Site Development Plan_V1.pdf Markup Summary

FOX RUN SUBSTATION		SITE PLAN	
TRI-STATE GENERATION & TRANSMISSION ASSOCIATION, INCORPORATED		4/12/2022 5:24 AM	
1100 W. 116th Ave. P.O. Box 33695 Denver, Colorado 80233 303-452-6111		KENDU	
Generation and Transmission Association, Inc.		Civl Dwg/Site Plan.dwg	
A Touchstone Energy Cooperative		No.	
Date: 12/16/21		Date:	
Appd:		Appd:	
Dwn: TMC		Dwn:	
Revision		Revision	
M.F.		M.F.	
Dwg. No.		M.F.R.	
Drawing Title		Reference Drawings

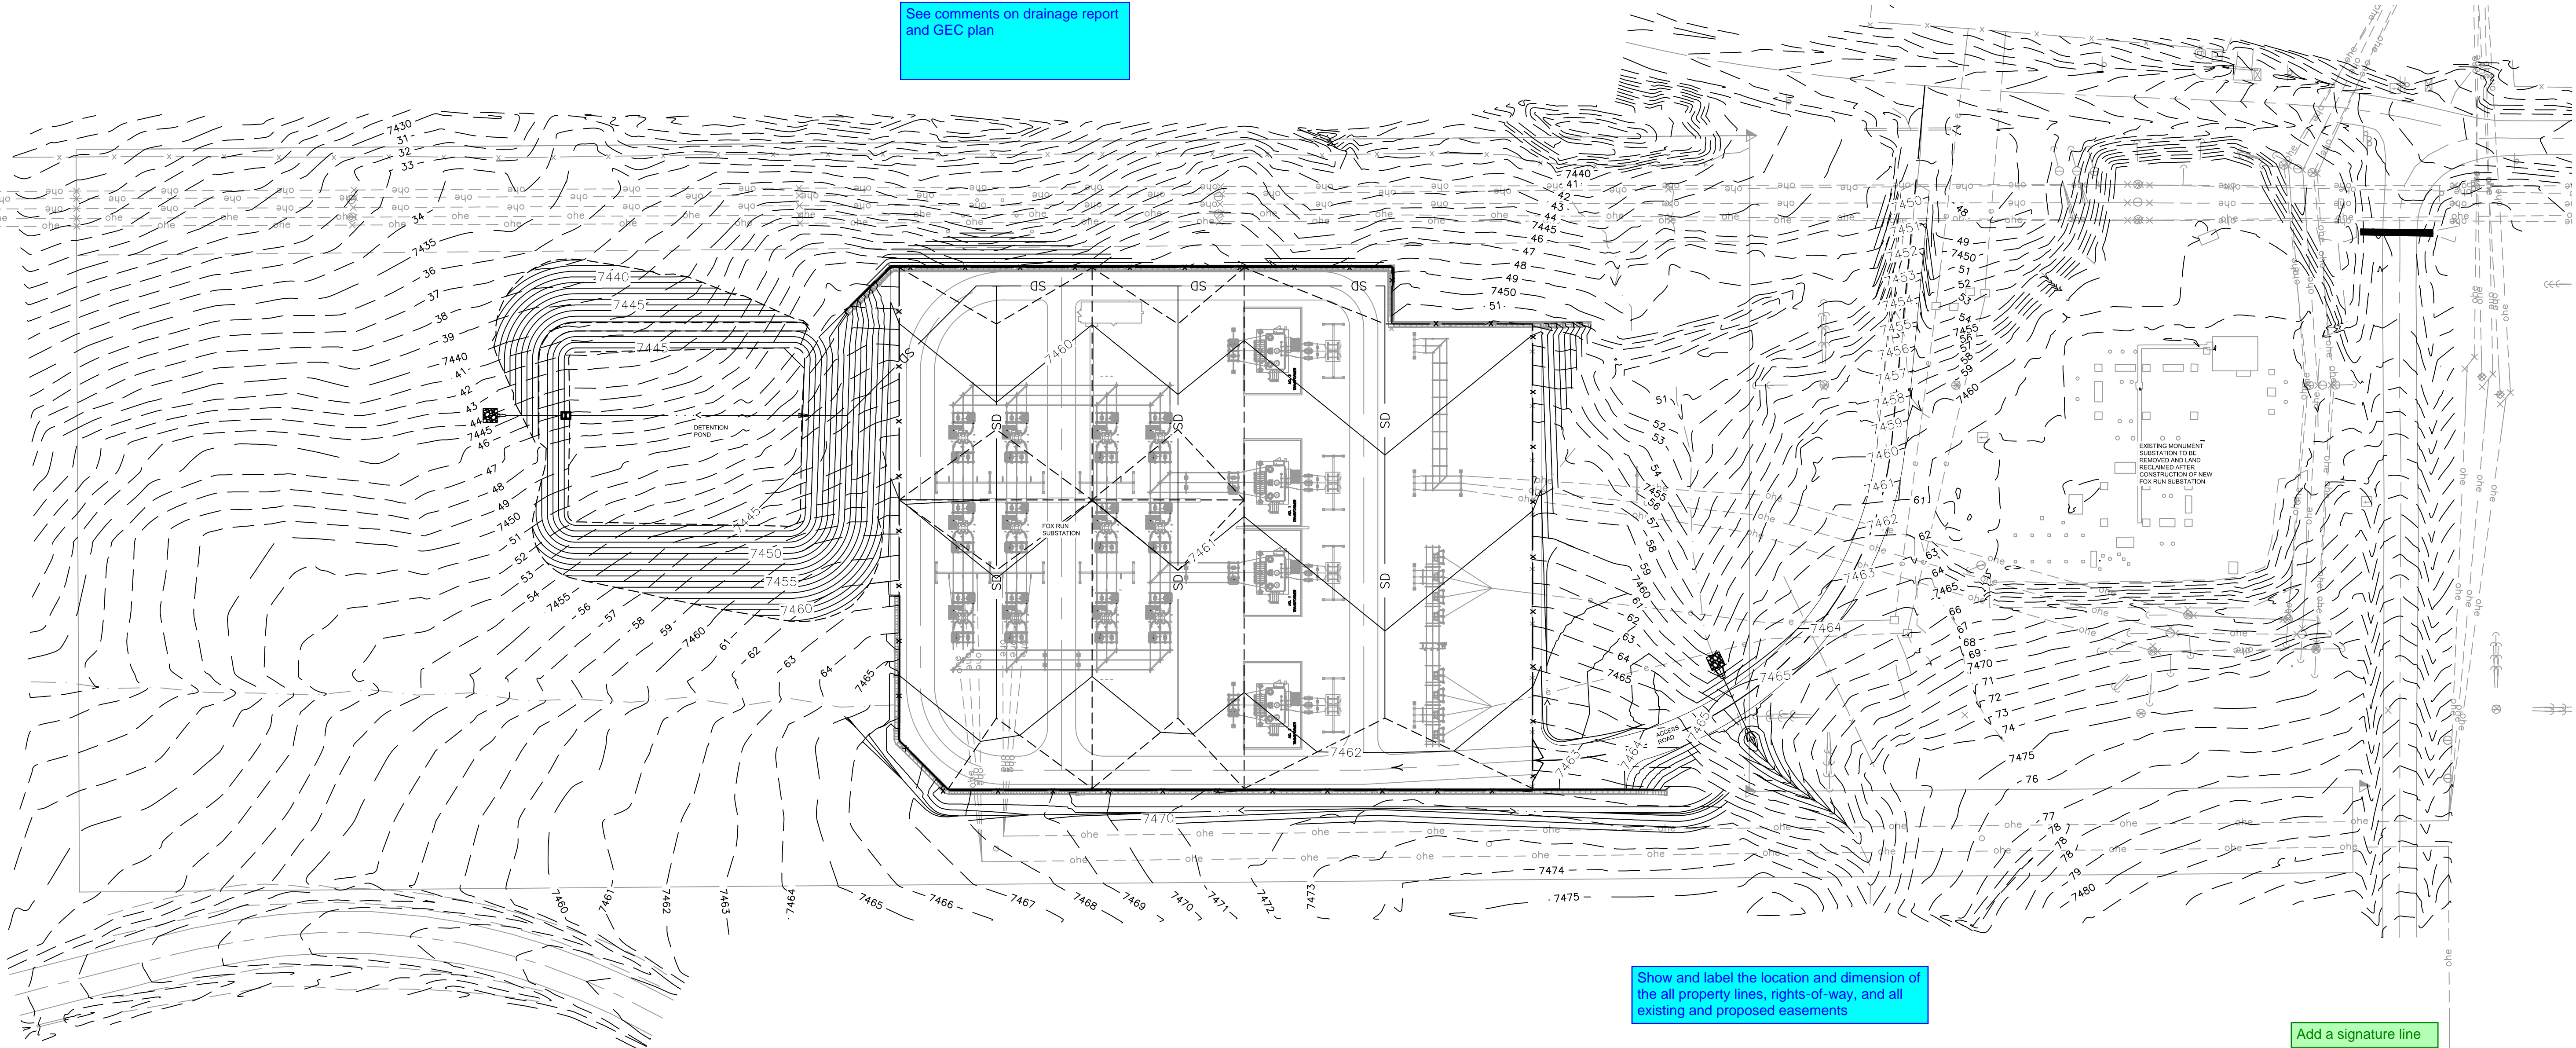
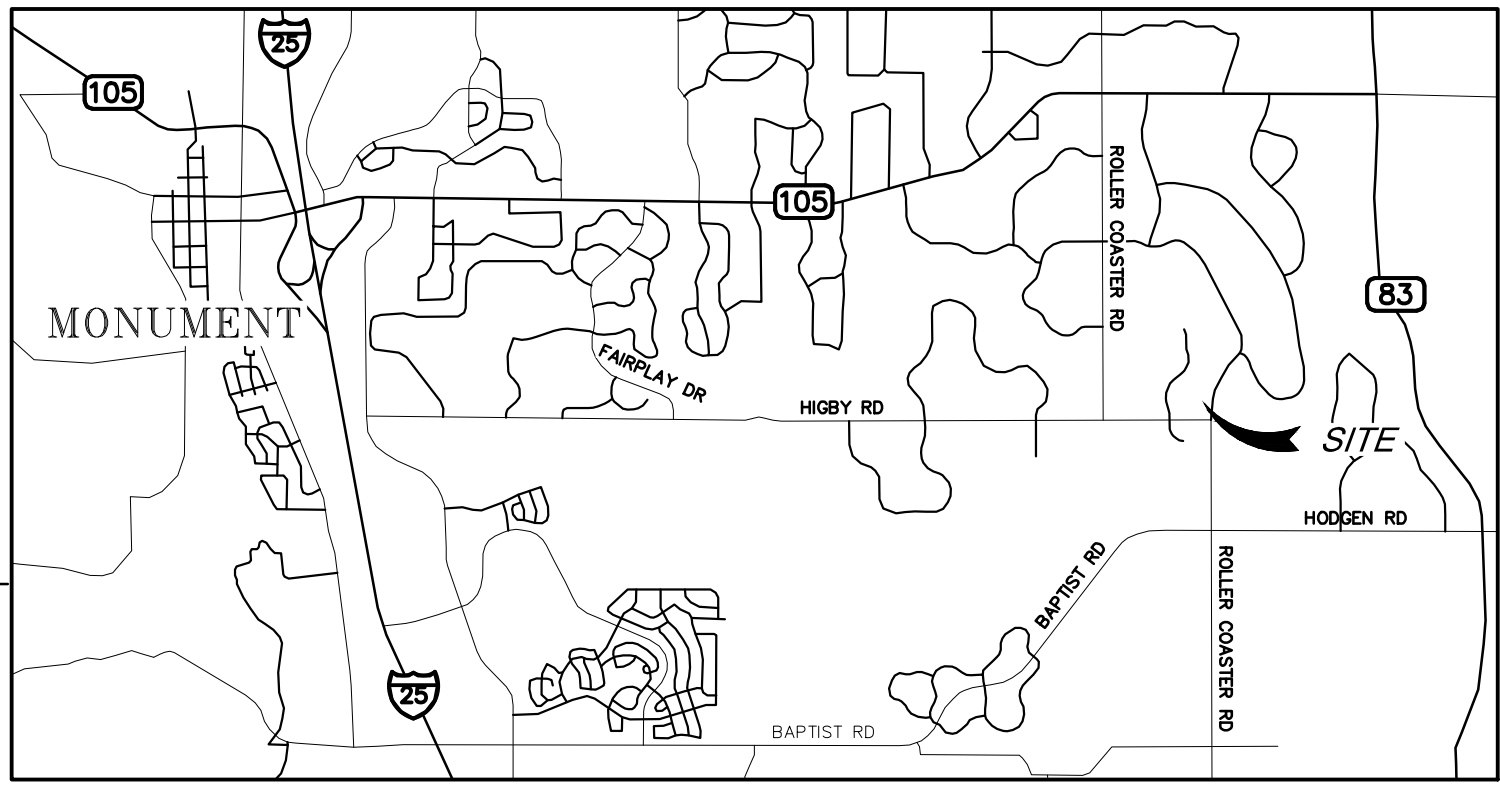
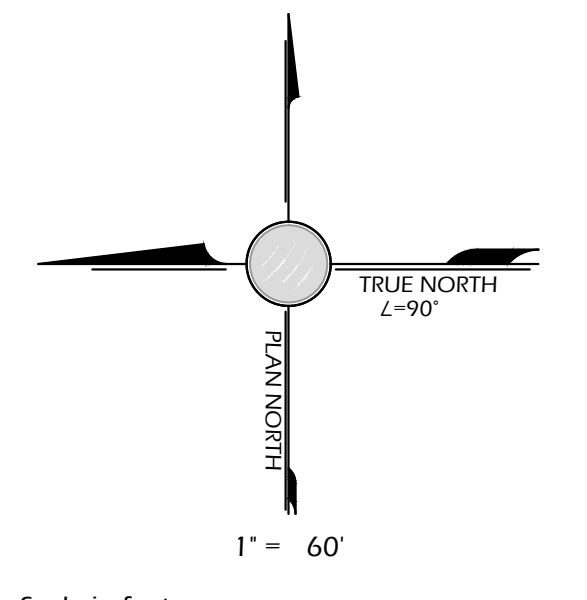
Verify correct address

- Include a summary table with:
 - Owner contact telephone number, and email for responsible party
 - Applicant name (if not owner), contact telephone number, and email for responsible party
 - Property address and property tax schedule number
 - Lot & Parcel size
 - Existing/proposed land use and zoning
 - Total gross building square footage - if any buildings are proposed
 - Location of all sidewalks, trails, fences and walls, retaining walls, or berms
 - Location and dimensions of all existing and proposed signage on site
 - Location and dimension of the all property lines, rights-of-way, and all existing and proposed easements

See comments on drainage report and GEC plan

Show and label the location and dimension of the all property lines, rights-of-way, and all existing and proposed easements

Add a signature line

Provide correct address, 1980 E Higby Road
Parcel # 6121003005

- Include a summary table with:
- Owner contact telephone number, and email for responsible party
 - Applicant name (if not owner), contact telephone number, and email for responsible party
 - Property address and property tax schedule number
 - Lot & Parcel size
 - Existing/proposed land use and zoning
 - Total gross building square footage - if any buildings are proposed
 - Location of all sidewalks, trails, fences and walls, retaining walls, or berms
 - Location and dimensions of all existing and proposed signage on site
 - Location and dimension of the all property lines, rights-of-way, and all existing and proposed easements

Add PCD File PPR-22-044

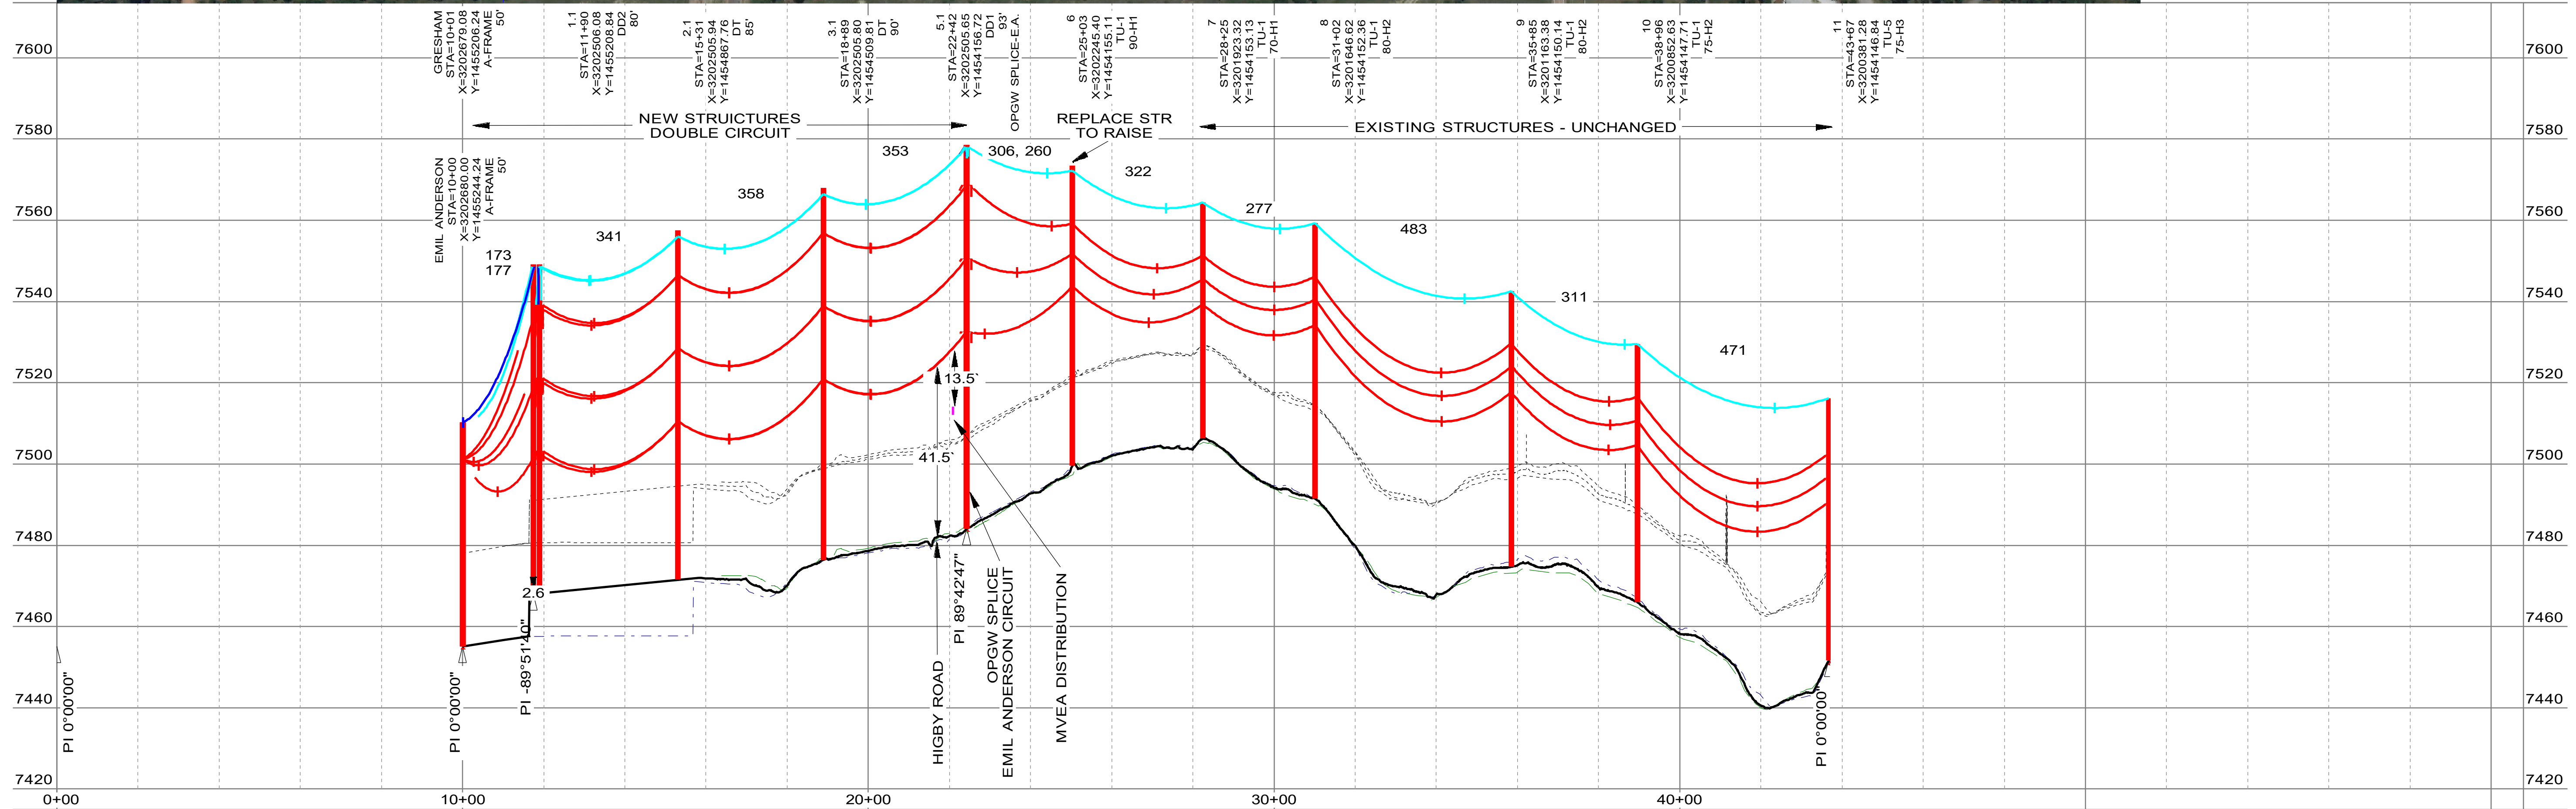
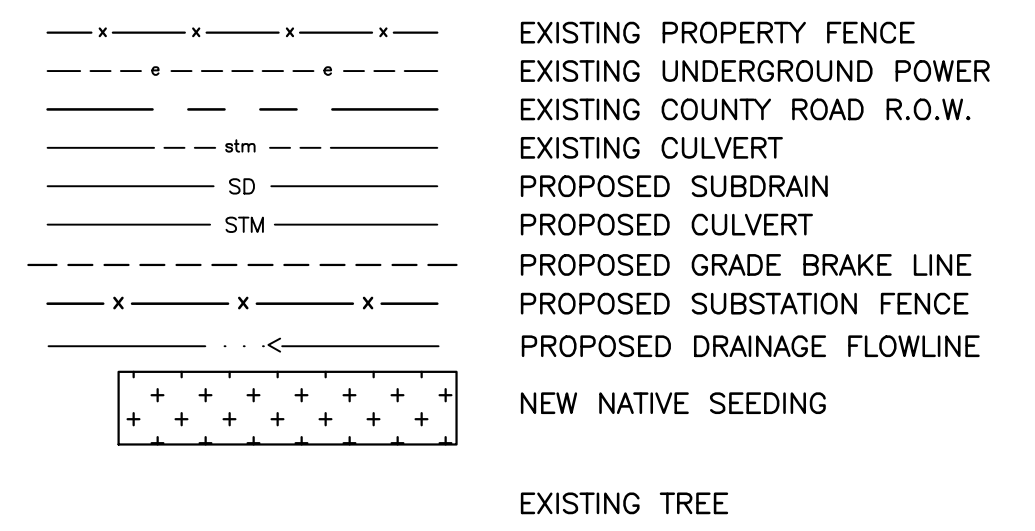
Add undisturbed native areas for total lot area to match project boundary

Lot is 652,806sqft
